RE: EWO – Olympic Steel (S20A0480A)

Nucor Building Systems has completed an engineering analysis of existing Nucor job #S08A0480A. The EWO included investigating the impacts of updating the building code to IBC 2018. The follow loads are as follows:

PROJECT NAME: OLYMPIC STEEL  
 SUMTER, SC  
 CUSTOMER: THOMPSON TURNER CONSTRUCTION CO.  
 SUMTER, SC

**CROSS SECTION @ LINES 1&3**

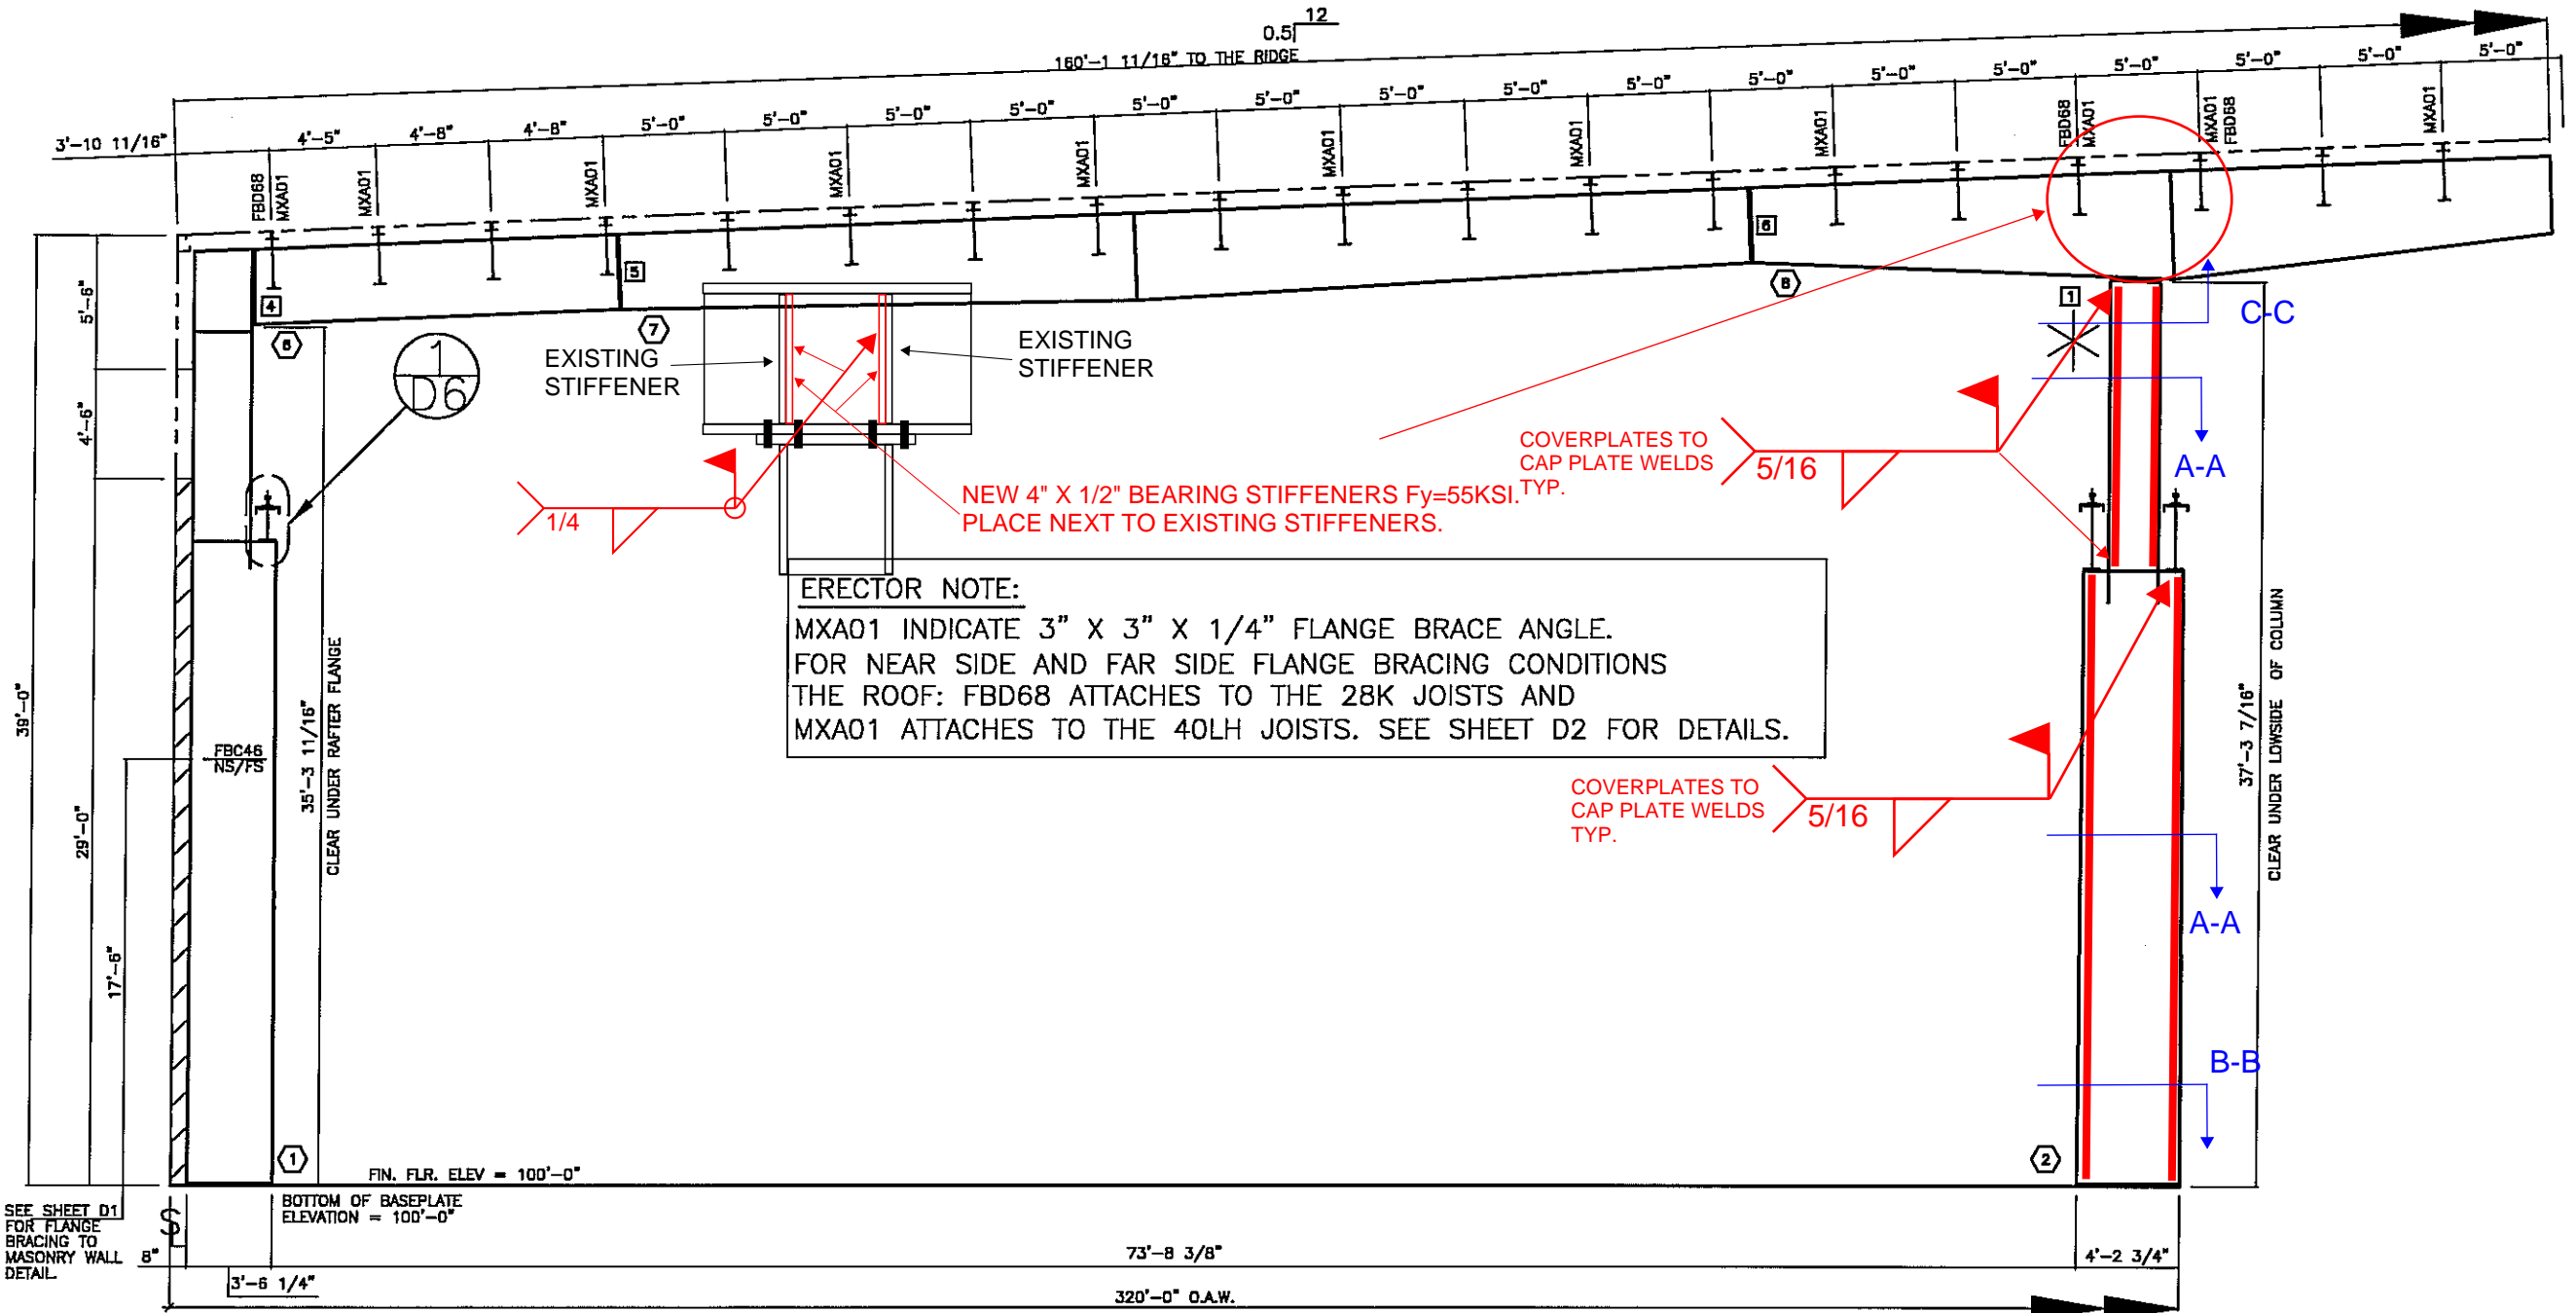
COVERPLATES TO CAP PLATE WELDS TYP. 5/16

**CROSS SECTION @ LINES 5 & 8**

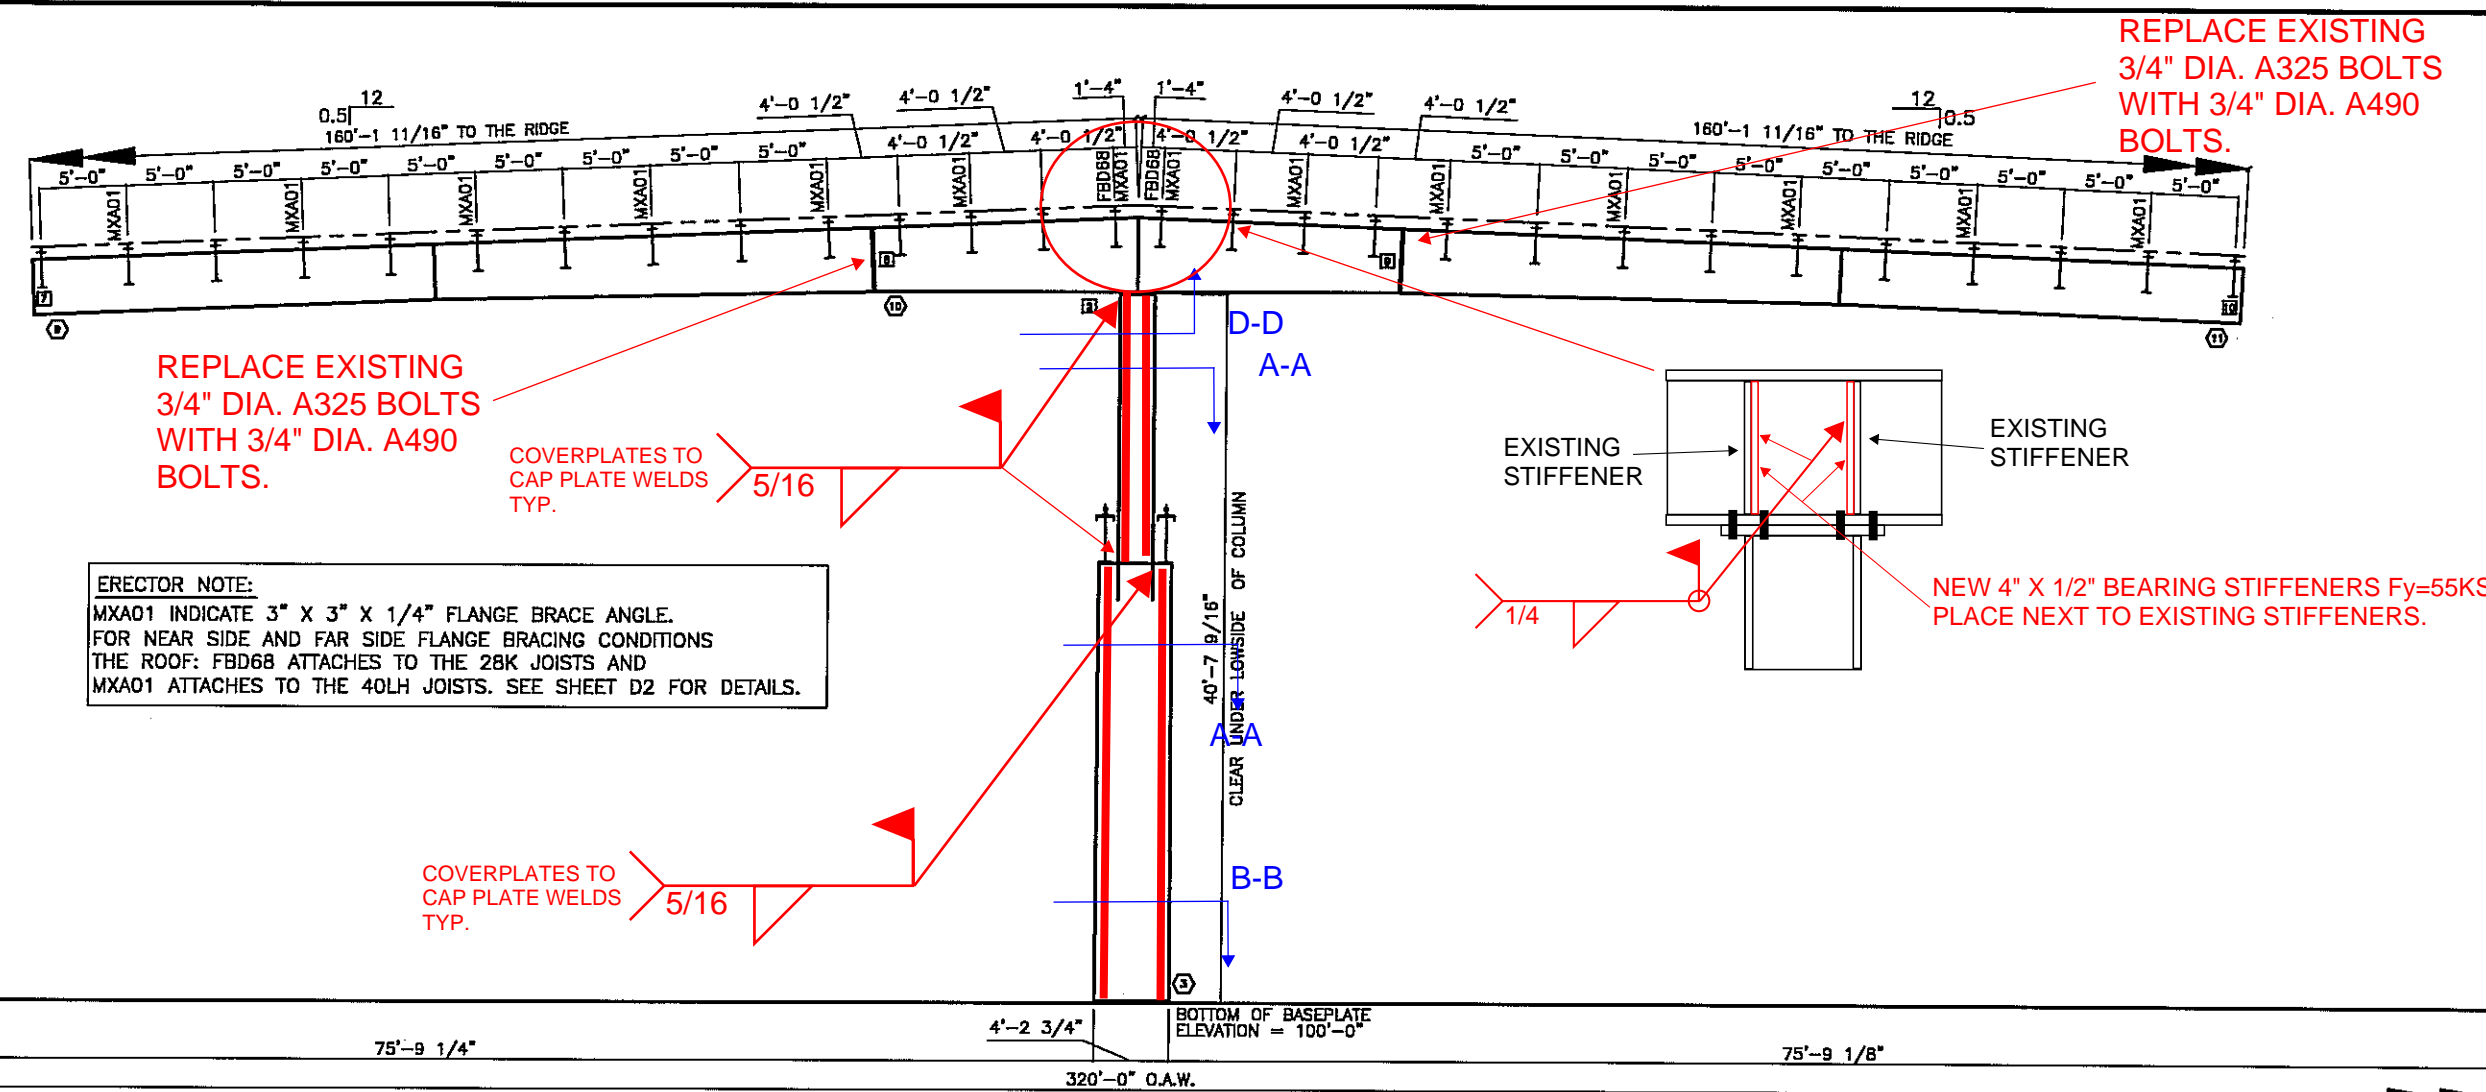
- 3) Frame lines 5-8 will require the following reinforcements:
  - a. The column flanges on lines E, J, and P will required cover plates.
  - b. The stiffeners in the fixed base connection will be field cut back to allow the cover plates to extend to the base plate.

- c. The moment connections above the columns on lines E, J, and P will require bearing stiffener reinforcements and additional holes will be field drilled into the connection for the attachment of additional bolts.
  - d. (2) Endplates per frame (10 total) will require bolt replacements.
  - e. See pages 8-10 for the fieldwork required.
- 4) A separate submittal from Vulcraft will be sent at a later date with the investigation results for the roof joist.

REPLACE EXISTING 3/4" DIA. A325 BOLTS WITH 3/4" DIA. A490 BOLTS.

COVERPLATES TO CAP PLATE WELDS TYP. 5/16

CROSS SECTION @ LINES 5 & 8

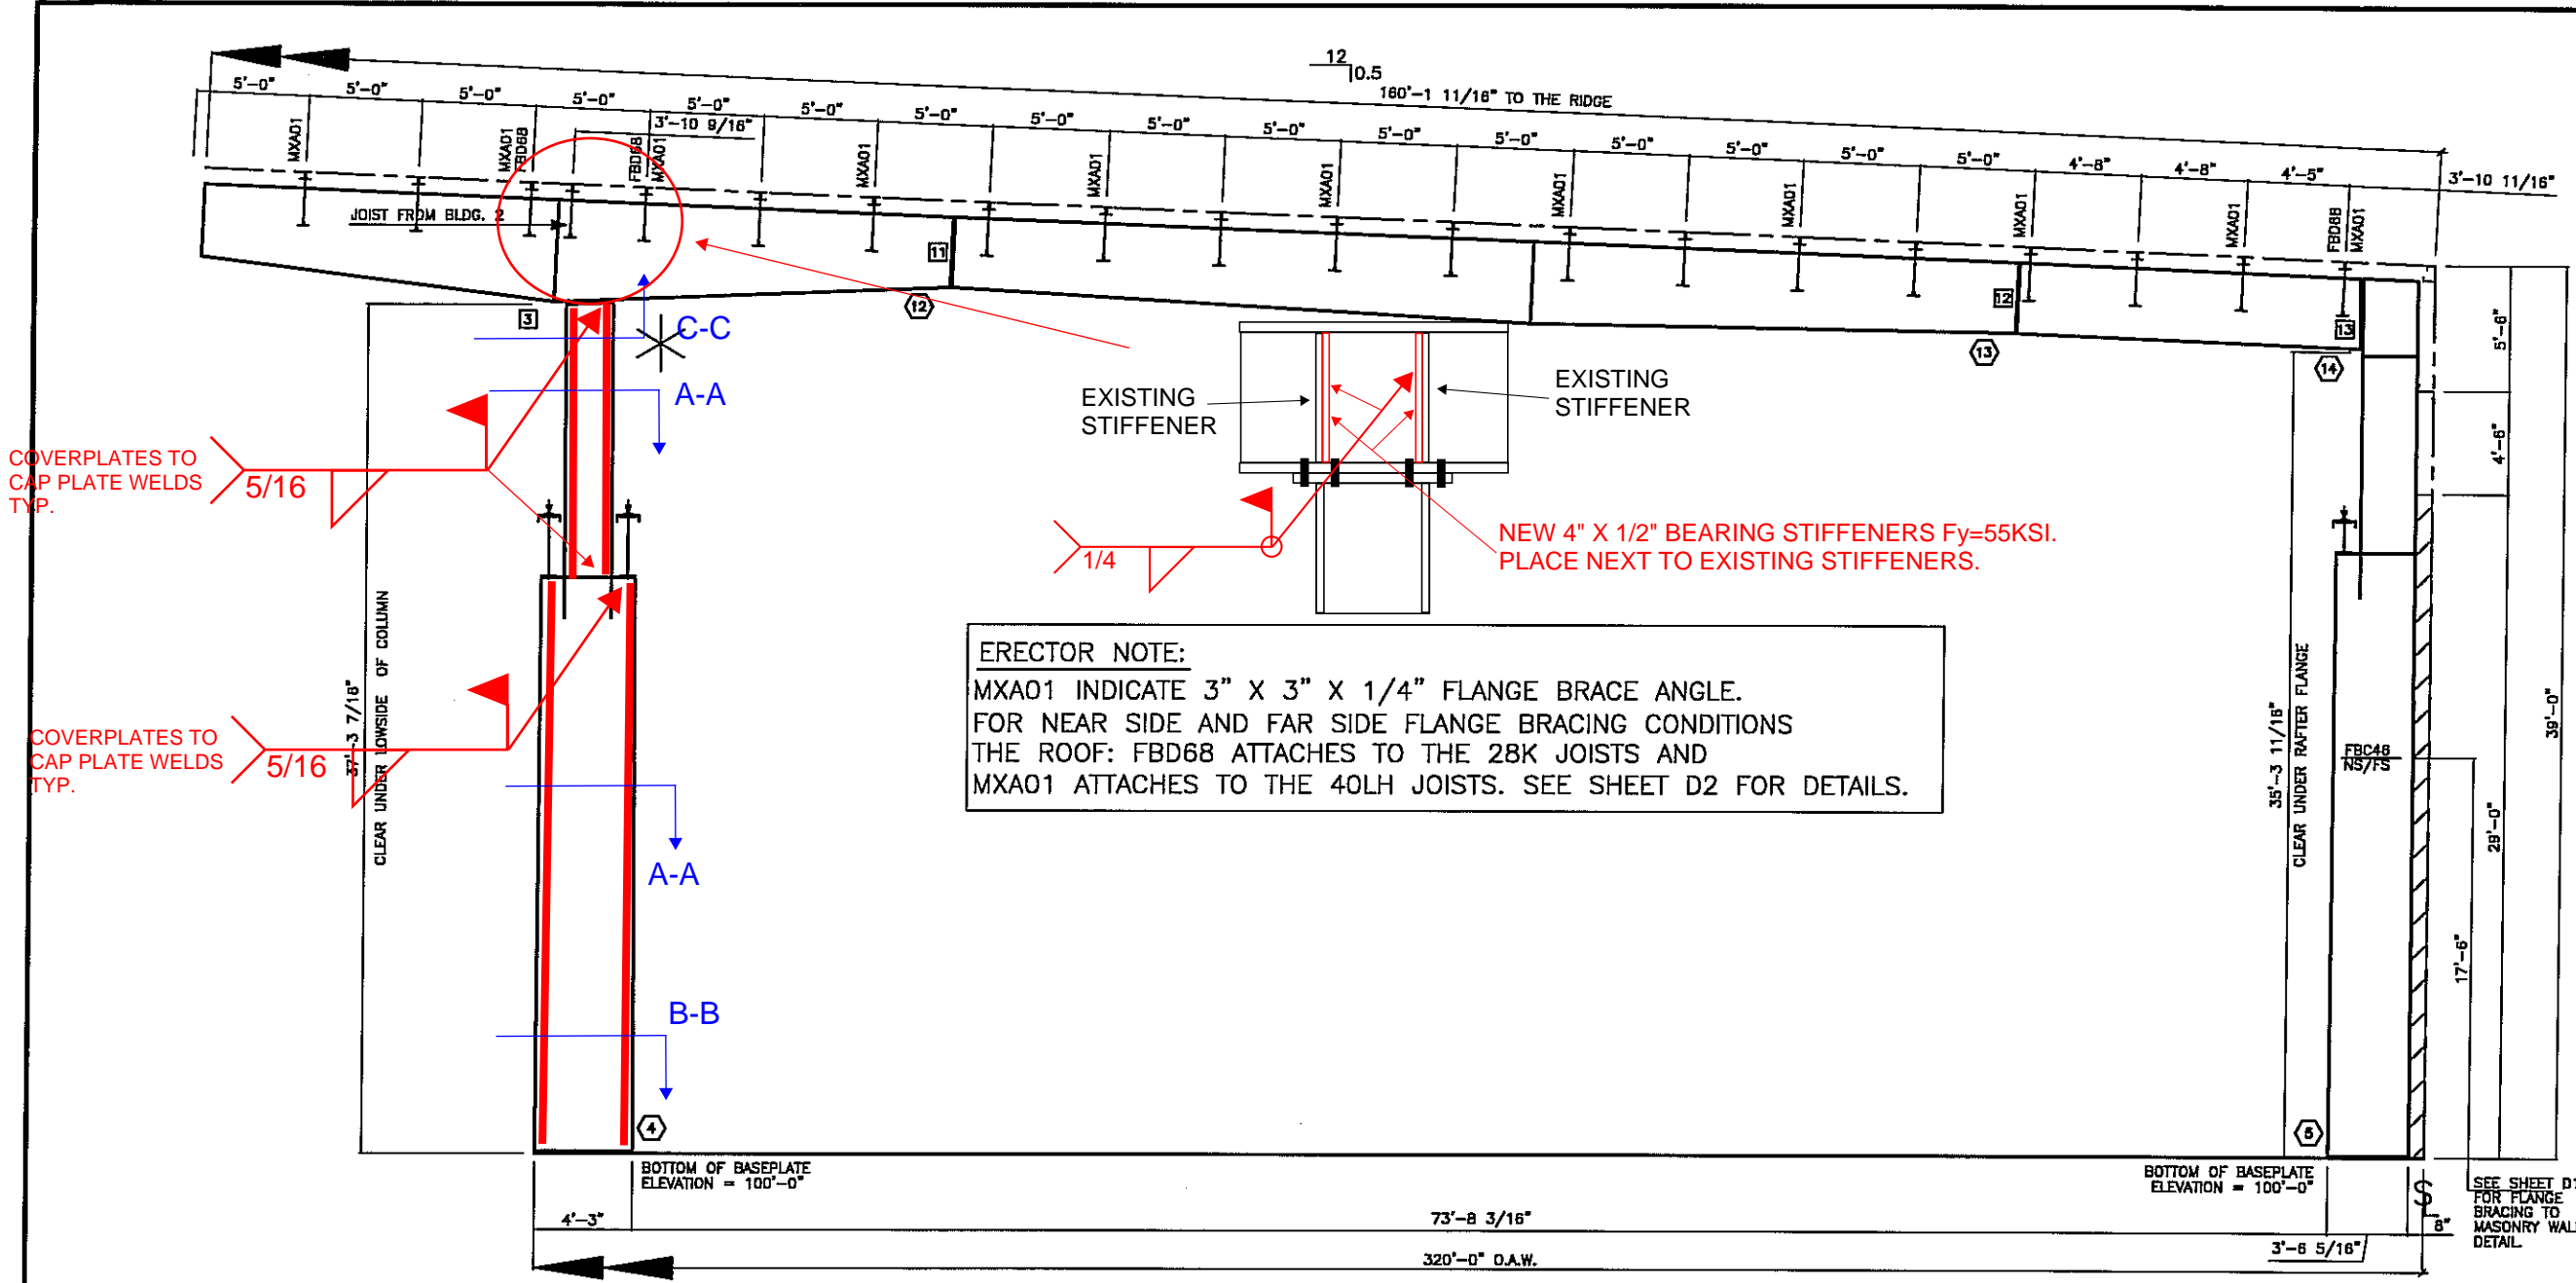
COVERPLATES TO CAP PLATE WELDS TYP. 5/16

EXISTING STIFFENER  
 EXISTING STIFFENER  
 NEW 4" X 1/2" BEARING STIFFENERS Fy=55KSI. PLACE NEXT TO EXISTING STIFFENERS.
